SERVICE BULLETIN

APPLICABILITY: 2012MY Impreza
SUBJECT: ABS Wheel Speed Sensor (rear)

NUMBER: 06-42-12

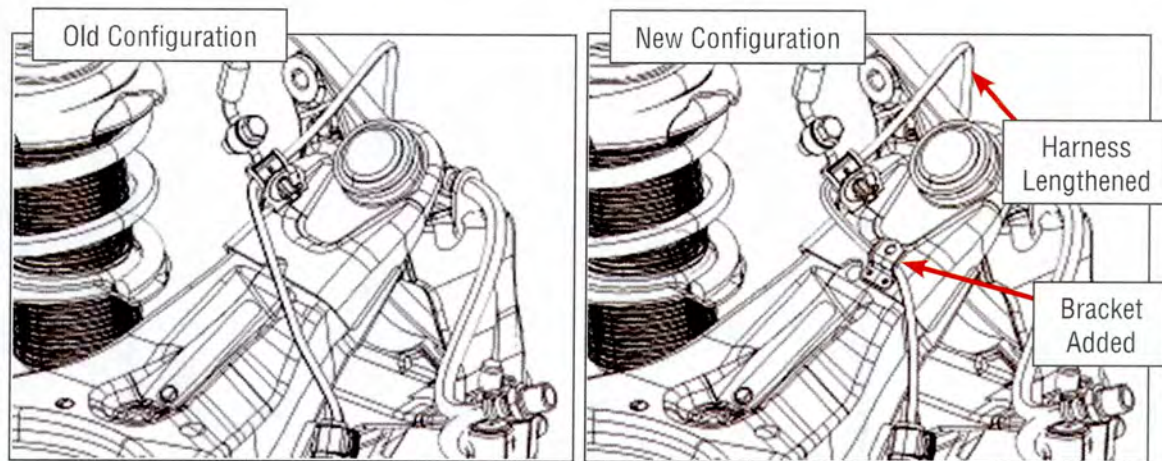
The purpose of this bulletin is to inform you of a change made to the rear ABS Wheel Speed Sensors. For manufacturing purposes, the length of the wiring harness was increased by 15mm. A bracket was also added to the rear upper arm assembly to secure the harness.

NO.	PART NAME	OLD PART #	NEW PART #	INTERCHANGEABILITY
1	Sensor Assembly Right Rear	27540FJ100	27540FJ020	New part # to vehicle within old part # VIN range: Yes (necessary to replace No.1 and No. 2 at the same time).
2	Arm Assembly, Right Rear, Upper	20252FJ000	20252FJ020	Old part # to vehicle within new part, # VIN range: No
3	Sensor Assembly Left Rear	27540FJ110	27540FJ030	New part # to vehicle within old part # VIN range: Yes (necessary to replace No.3 and No. 4 at the same time).
4	Arm Assembly, Left Rear, Upper	20252FJ010	20252FJ030	Old part # to vehicle within new part # VIN range: No

Note: The old style sensors have a white mark next to the part number stamping.

Refer to the applicable service manual for replacement procedure. **Note:** If replacing the rear upper arm assembly, a new self-locking nut must be used.
